# Conceptual Design Recommendations for Improving Steelhead Migration at Cliff Drive Apron on Arroyo Burro

June 25, 2004

### **Review of URS Proposed Fish Passage Weir Design:**

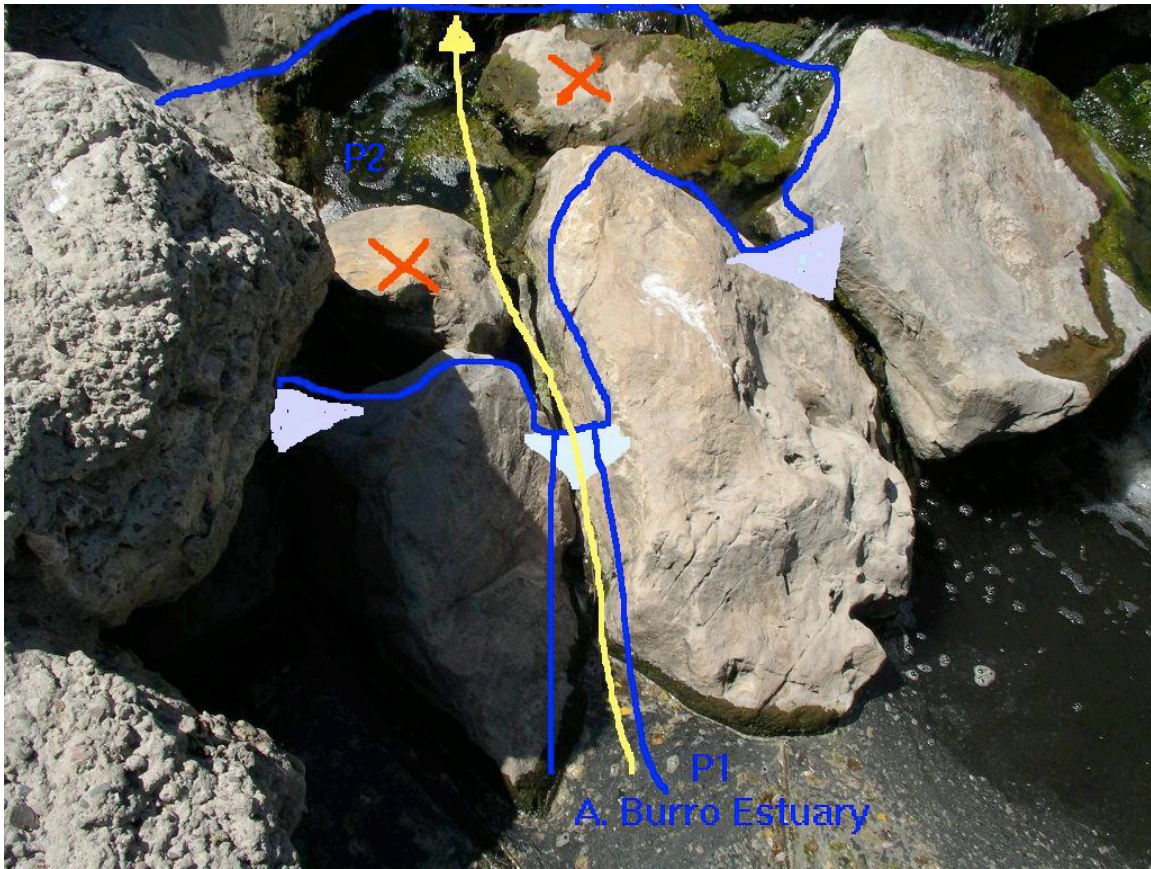
Within the *Project Description Upper Arroyo Burro Estuary Restoration Report* (2003) URS proposed that, “The City will install three concrete, rock-like weirs on the existing grouted rock rip-rap apron downstream of Cliff Drive bridge to create small jump pools that will enhance the passage conditions for steelhead. The structures will be designed in the field, following the specifications on Sheet 13, Appendix C). Anchor bolts will be drilled into the existing rock at the site, and then a wood form will be constructed and filled with reinforced concrete. The work area will be dry during construction due to an upstream diversion and flow by-pass system.” Photograph simulations show the potential weir locations downstream of the concrete curb.

This proposed modification would likely improve steelhead passage by increasing jump pool depth across the apron. The main potential problem with this design is that the four jumps will exceed NOAA Fisheries maximum hydraulic drop or jump height criteria of 12 inches. The average hydraulic drop for the design would average over 12 inches per jump with the 58-inch vertical height to be overcome from the estuary surface to the top of the concrete curb.

NOAA Fisheries minimum adult steelhead design criteria calls for hydraulic drops (also referred to in this report as “jump heights”) not to exceed 12 inches and downstream jump pool depth to be at least 24 inches. In order to meet these adult steelhead design criteria, within the limitations of the project parameters listed above, a 10-inch deep notch can be cut in the concrete curb to change the curb’s elevation above the estuary from 58 inches to 48 inches. This reduction in curb elevation will allow for the creation of three step pools with four 12-inch jump heights allowing adult steelhead to overcome the concrete curb. Juvenile steelhead passage would be improved and provide limited upstream migration. The removal or cutting of seven existing boulders will increase the step pool depths and provide sufficient jump depths for adult steelhead to gain effective jumping velocities. Removal of key boulders will also eliminate obstacles currently blocking migration routes and jump landing areas. Juvenile steelhead passage would be greatly improved with this design, but would not meet the conservative 6-inch jump height criteria set by NOAA Fisheries for juvenile steelhead passage design.

**Estuary (Pool #1), Jump #1, Pool #2**

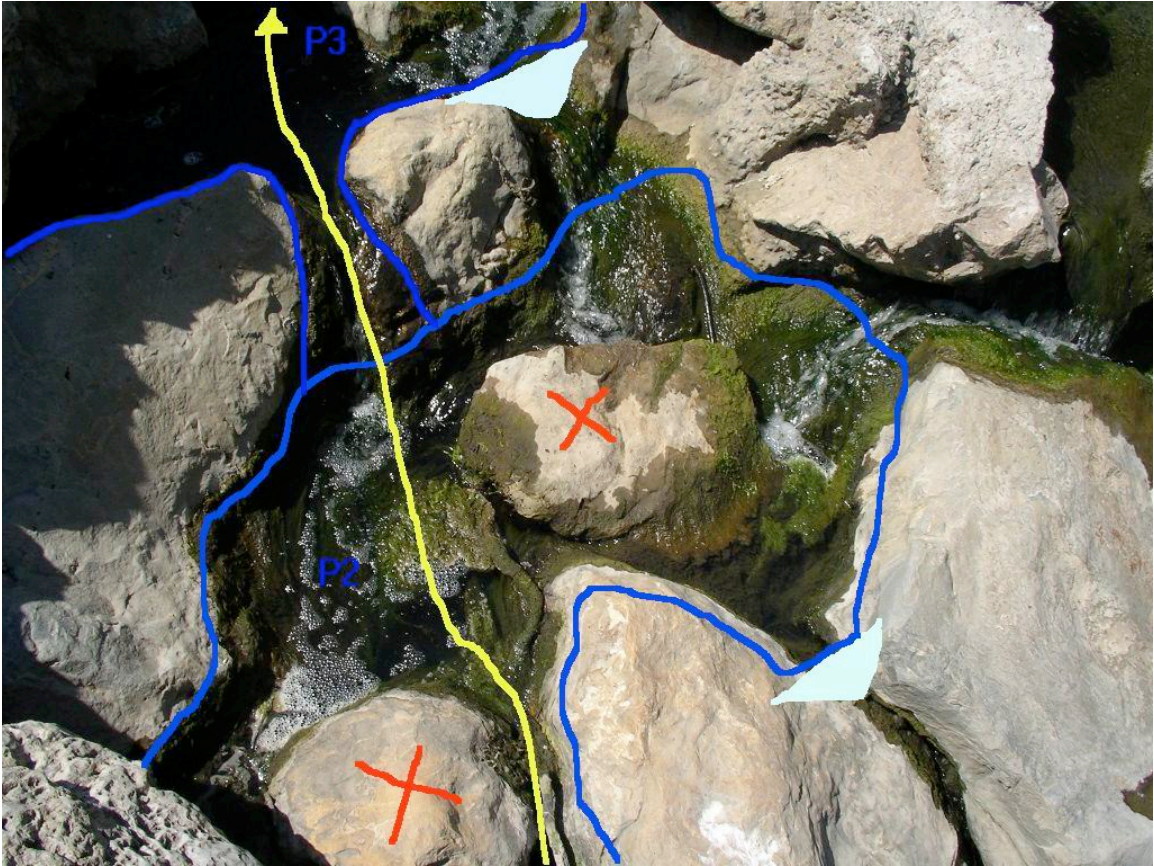
The Arroyo Burro estuary P1 provides sufficient jump depth to allow steelhead to jump into P2 during the encountered base stream flows. During moderate and high stream flow conditions or with elevated sandbar development, the estuary water surface elevation can rise several feet and submerge the lower portion of the apron. Two boulders limit the size and depth of P2. Removal of these boulders (marked with red X's) would increase the pool depth to a maximum depth of at least 27 inches. Removal of these boulders may provide additional depth depending on extent of the lower buried portion. Both boulders appear to be resting on top of other boulders. The modified pool would measure approximately 50 inches longitudinally and 72 inches wide. The potential addition of reinforced concrete sills, as shown, should be determined following the completion of curb notching and upstream modifications described below. Once upstream modifications are made and 12 inch hydraulic drops are determined then the water surface elevation of P2 should be determined and sills developed to direct outflows at the yellow fish migration location. It is likely that these sills would be developed mainly to focus flows the outlet location shown and to seal off subsurface flows between boulders, but not to raise the pool surface elevation of P2. With these modifications and redirected flows, the new jump height for Jump #1 should be 12 inches or less (depending on estuary water elevation) to the new P2 outflow location.

**Pool #2 and Jump #2**

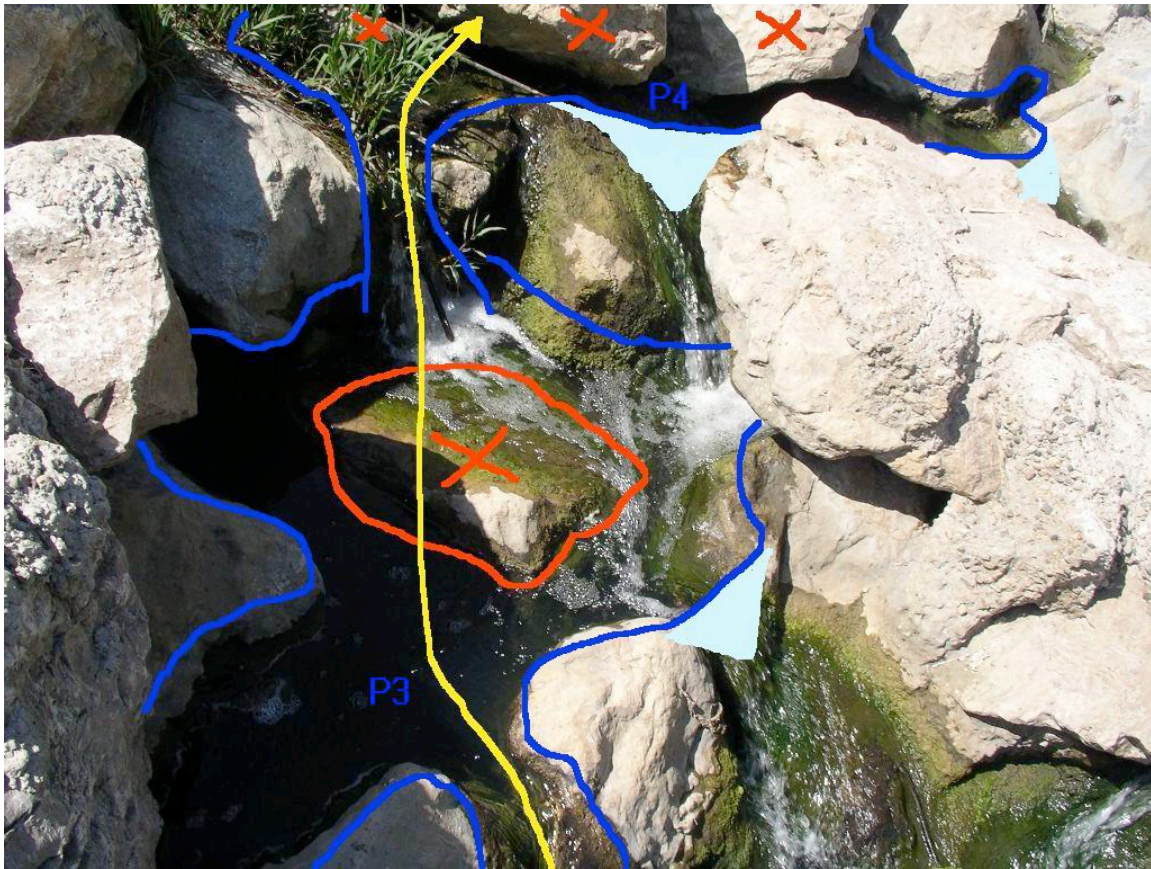
See previous summary for Estuary (Pool #1), Jump #1, Pool #2. Note: Flows entering the photograph from the right side would be refocused into the upstream end of the step pools with a concrete sill described in the summary for Pool #4 and Jump # 4 (Notched Concrete Curb).

**Pool #3 and Jump #3**

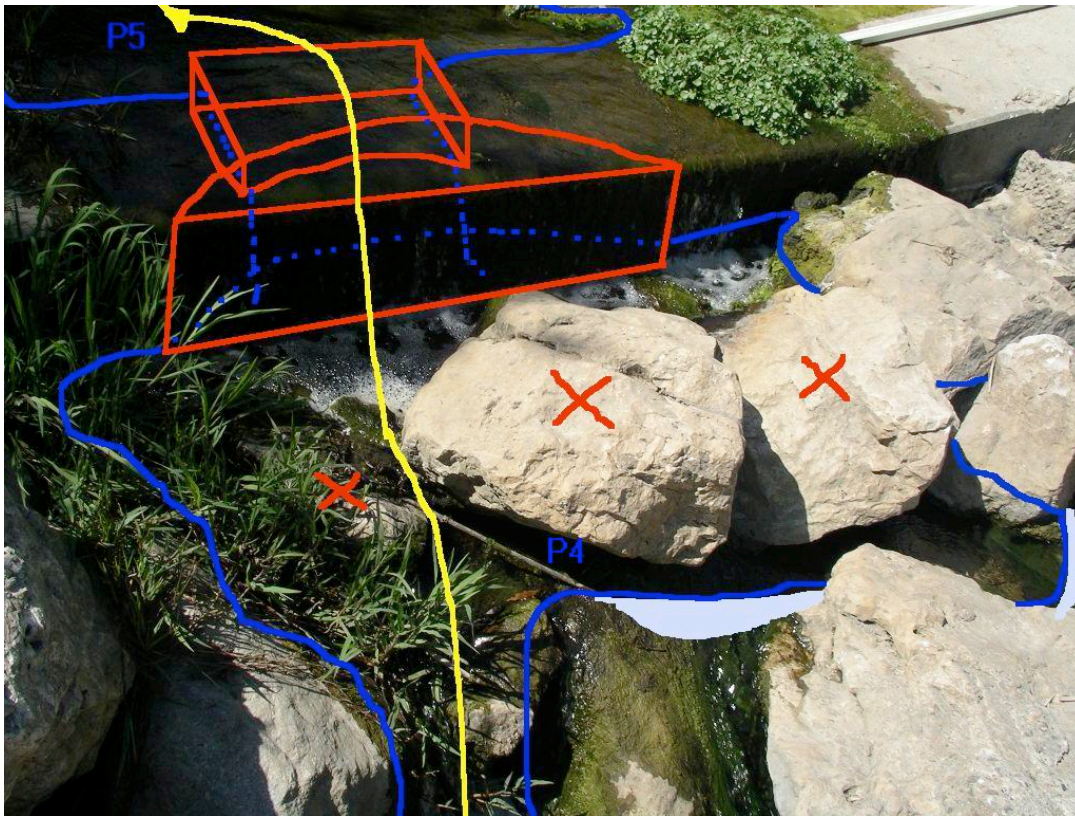
Remove a significant downstream portion of the boulder marked with a red X by cutting out the approximate circle shown to increase pool depth in P3 and remove this jump obstacle. This large boulder provides structural support for upstream and adjacent boulders and the extent to which portions can be removed will need to be determined by a qualified structural professional. The addition of concrete and/or other reinforcement to the pool bottom may be needed following boulder cutting. Identify the elevation for the tailwater control for P3 at 12 inches below the elevation of the top of the Jump #3 upstream following curb notching and upstream modifications. The outlet elevation for P3 should be close to the existing elevation control where the yellow steelhead migration line occurs. Construct one concrete sill near shown location to ensure that flows are focused down the yellow fish migration line outlet location. The concrete sills should be approximately 4 inches higher in elevation than the outlet elevation at the yellow line location.

**Pool #4 and Jump # 4 (Notched Concrete Curb)**

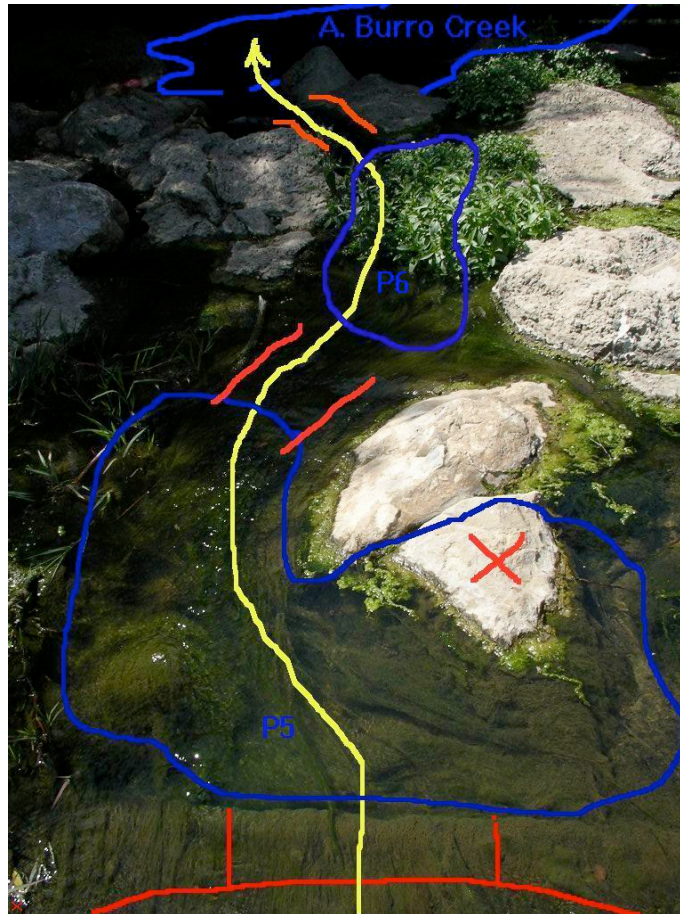
Removal of a half-oval section of the concrete curb as shown will expand the size of jump pool P4 and reduce the horizontal jump across the notch in the curb. This half-oval should measure approximately 5 feet across on the downstream side and extend 15 inches upstream into the curb to the center/apex of the half-oval. If structurally feasible, the removed half-oval will comprise the entire thickness of the curb (24 inches). Remove a notch from the remaining concrete curb at the upstream side of the removed half-oval section. The notch should be centered at the apex of the removed half-oval and measure approximately 3 feet wide, 10 inches deep, and be aligned in a perpendicular manner from the upstream edge of the curb. Removal of the three boulders marked with red X's will allow development of 24-inch pool depth in P4 and eliminate obstacles to upstream migration. If boulder removal does not add 12 inches of pool depth and create the desired 24-inch minimum pool depth then excavate slightly to develop desired pool depth. Following curb modification, boulder removal, and pool development identify the location for the tailwater control elevation for P4 at 12 inches below the downstream edge of the notch cut in the concrete curb. This outlet location and elevation should be close to the existing elevation control where the yellow steelhead migration line occurs. The tailwater elevation may need to be lowered slightly by cutting into existing rock and producing an outlet flow notch. Construct two concrete sills near shown locations to ensure that low flows are focused down the yellow fish migration line location. These concrete sills should be approximately 4 inches higher in elevation than the elevation of the outlet location at the yellow line.
